Lee County, Florida
DEPARTMENT OF COMMUNITY DEVELOPMENT
ZONING SECTION
STAFF REPORT

CASE NUMBER: DCI2022-00036
CASE NAME: TROPICAL FENCE CPD
TYPE OF CASE: MINOR PLANNED DEVELOPMENT
HEARING EXAMINER DATE: FEBRUARY 16, 2023
SUFFICIENCY DATE: DECEMBER 13, 2022

393 AND 397 BALBOA AVENUE
MASTER CONCEPT PLAN

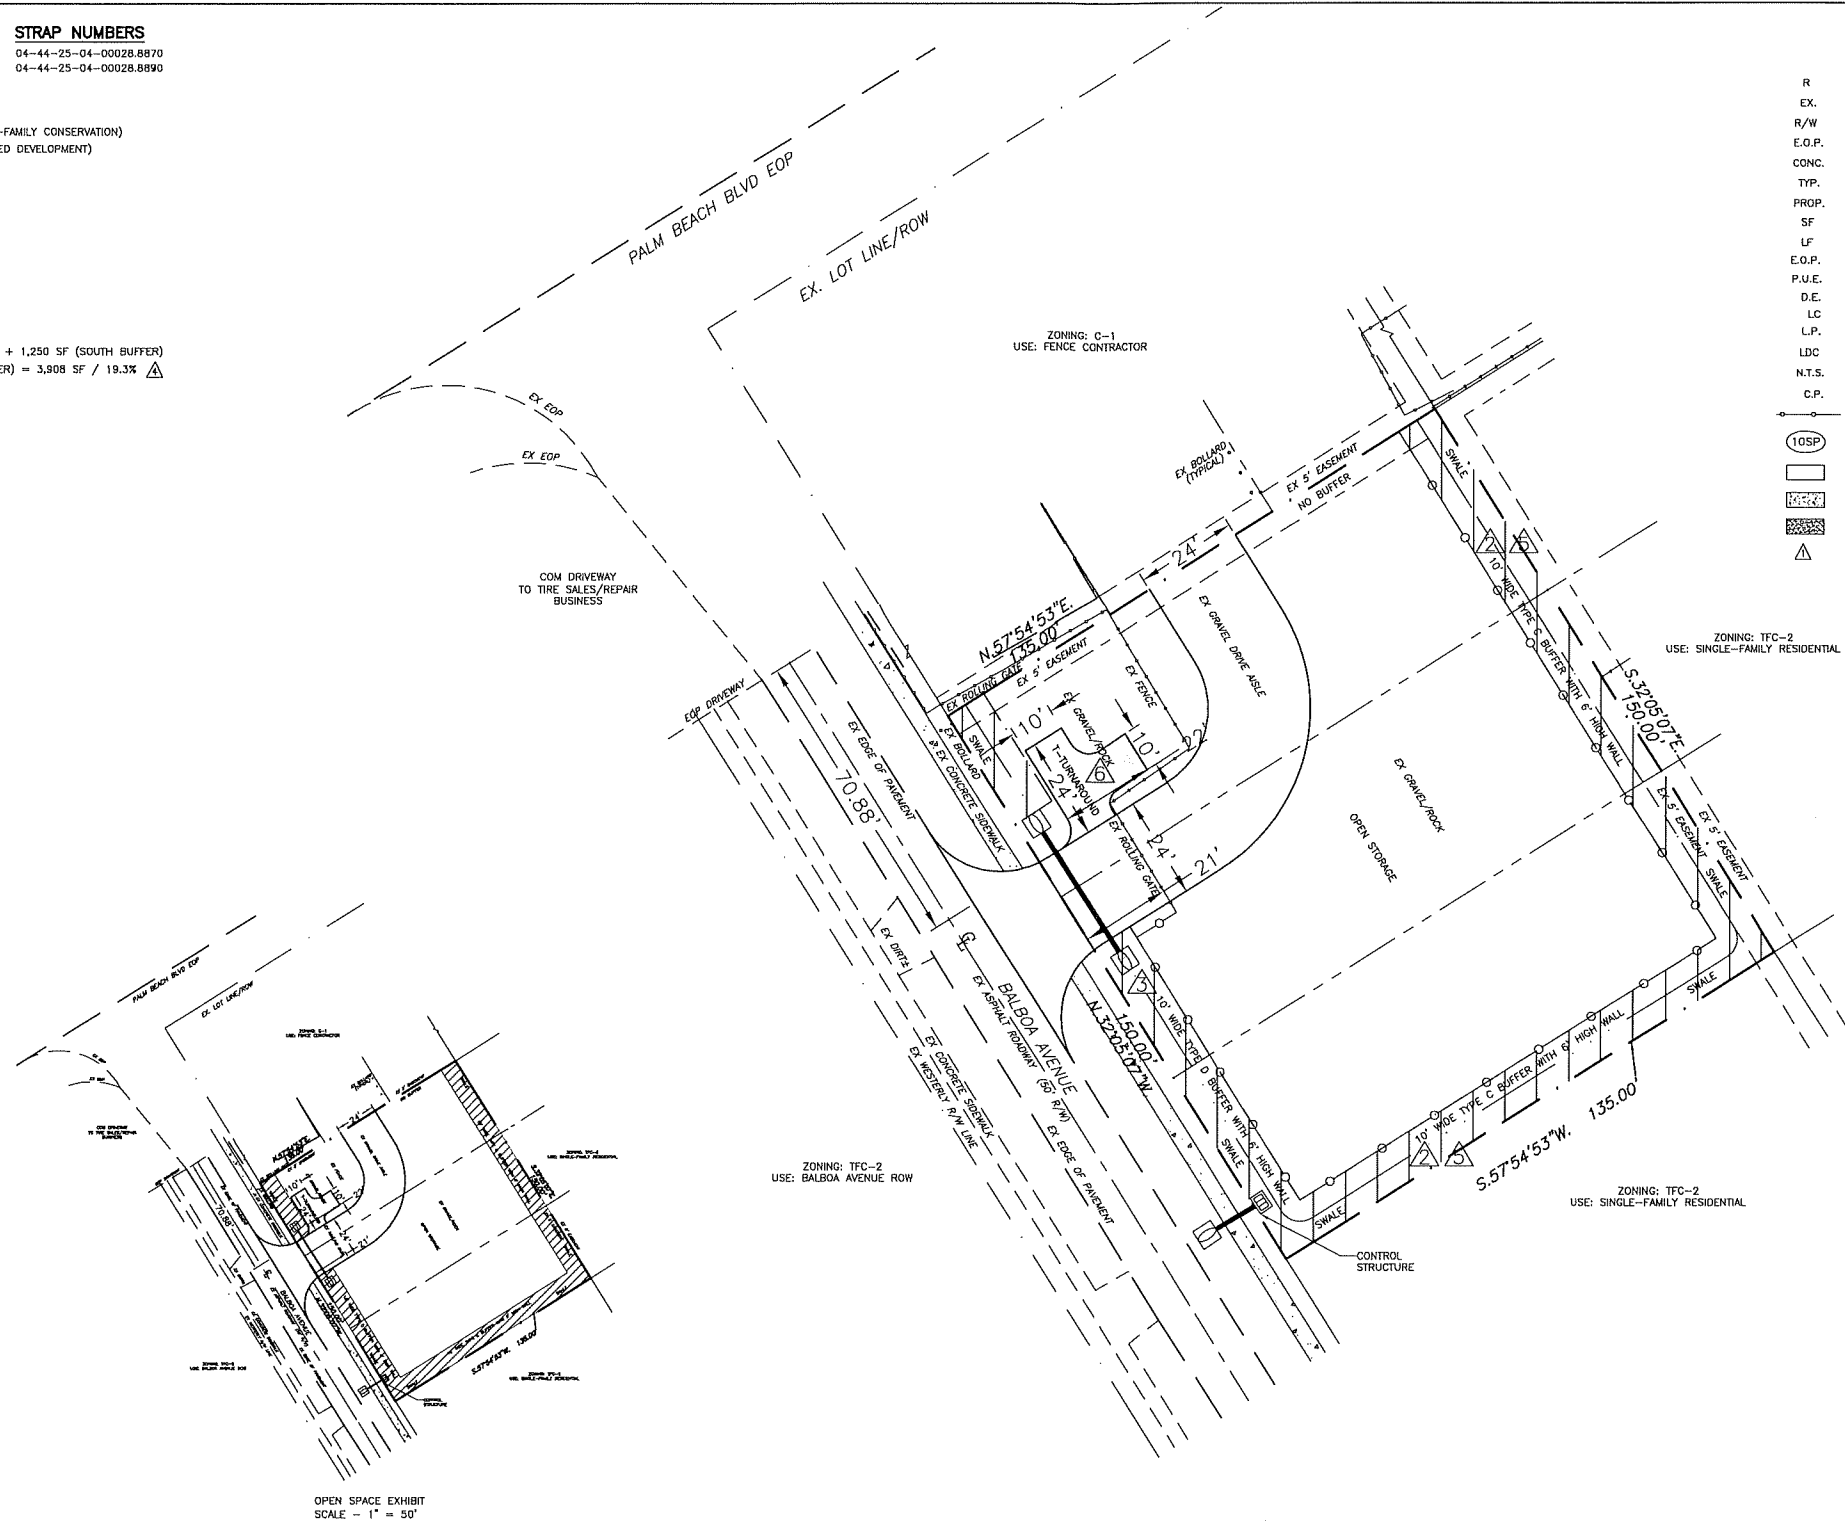
1. Deviation (1) Withdrawn.
2. Deviation (2) seeks relief from the LDC Section 10-416(d)(4) requirement for a Type C buffer to be 15-feet-wide with 5 trees and 18 shrubs per 100 linear feet with a solid wall, berm, or wall and berm combination, not less than 8 feet in height as measured from the finished grade of the project site. Request to permit the Type C buffer to be 10-feet-wide with 5 trees and 18 shrubs per 100 linear feet, for all vegetation to be native species, for all plant materials to meet the standards for Florida No. 1 or better, for all trees to be a minimum of 12 feet in height at time of planting, for all shrubs to be 24 inches in height at time of planting, and for the wall, berm, or wall and berm combination to be 6 feet in height.

3. Deviation 3 seeks relief from the LDC Section 10-416(d)(4) requirement for a Type D buffer to be 15-feet-wide with 5 trees per 100 linear feet and double staggered hedge row. Request to permit the buffer adjacent to Balboa Avenue to be 10-feet-wide with 5 trees per 100 linear feet, a double-staggered hedge row, for all vegetation to be native species, for all trees to be a minimum of 12 feet in height at time of planting, and for all plant materials to meet the standards for Florida No. 1 or better.

4. Deviation 4 seeks relief from the LDC Section 10-415 requirement for small commercial developments to provide a minimum of 20% open space. Request to permit a minimum of 19% open space.

6. Deviation 6 seeks relief from the LDC Section 34-1748(5) requirement that a paved turn-around, having a turning radius sufficient to accommodate a U-turn for a single unit truck, must be provided on the ingress side of the gate. The applicant is requesting to provide a T-turnaround for passenger cars as shown on the MCP.

Deviation #2 is being requested to allow a Type-C buffer to be ten-feet-wide with five trees and 18 shrubs per 100 linear feet. The buffer vegetation is required to be native species with twelve-foot-in-height trees and 24-inch shrubs at time of planting. The applicant has stated that the landscape material will be Florida #1 or better but this specification is required by LDC Section 10-420(a). The wall or wall berm combination height is proposed to be six-feet-in-height with the twelve foot tree making up the two foot difference.

The applicant is required to provide a right-of-way buffer per LDC Section 10-416(d). The right-of-way buffer abutting Balboa Avenue must be 15-feet-wide with a six-foot-high solid opaque fence setback 15 feet with five trees per 100 linear feet and a double staggered hedge. The applicant is requesting Deviation #3 to allow a ten-foot-wide buffer with five trees per 100 linear feet and a double staggered hedge row. The buffer vegetation must be native species, the trees must be installed at 12-feet-in-height, and all material will be Florida #1 or better per LDC Section 10-420(a). The applicant must provide a six-foot-high fence setback the width of the buffer to screen the storage area.

Prior to development order approval, the applicant must depict on the landscape plans a ten-foot-wide buffer with a six-foot-high solid opaque fence setback ten feet from the property line along the east and south property lines abutting the residential uses. The buffer must include five trees and 18 shrubs per 100 linear feet. The trees must be 12-feet-in-height with a three-inch caliper, and six-foot-wide canopy spread. The shrubs must be 24-inches-in-height. All buffer vegetation must be 100 percent native species.

Prior to development order approval, the applicant must depict on the landscape plans a ten-foot-wide right-of-way buffer with a six-foot-high solid, opaque setback ten feet and abutting Balboa Avenue. The buffer must include five trees per 100 linear feet and a double staggered hedge. The trees must be 12-feet-in-height with a three-inch caliper, and six-foot-wide canopy spread. The shrubs must be 24-inches-in-height. All buffer vegetation must be 100 percent native species.

At time of a development order submittal the applicant must provide signage indicating no parking in the area provided on the MCP for the T-turnaround.

Prior to development order approval, the applicant must depict on the landscape plans a ten-foot-wide buffer with a six-foot-high solid opaque fence setback ten feet from the property line along the east and south property lines abutting the residential uses. The buffer must include five trees and 18 shrubs per 100 linear feet. The trees must be 12-feet-in-height with a three-inch caliper, and six-foot-wide canopy spread. The shrubs must be 24-inches-in-height. All buffer vegetation must be 100 percent native species.

Prior to development order approval, the applicant must depict on the landscape plans a ten-foot-wide right-of-way buffer with a six-foot-high solid, opaque setback ten feet and abutting Balboa Avenue. The buffer must include five trees per 100 linear feet and a double staggered hedge. The trees must be 12-feet-in-height with a three-inch caliper, and six-foot-wide canopy spread. The shrubs must be 24-inches-in-height. All buffer vegetation must be 100 percent native species.
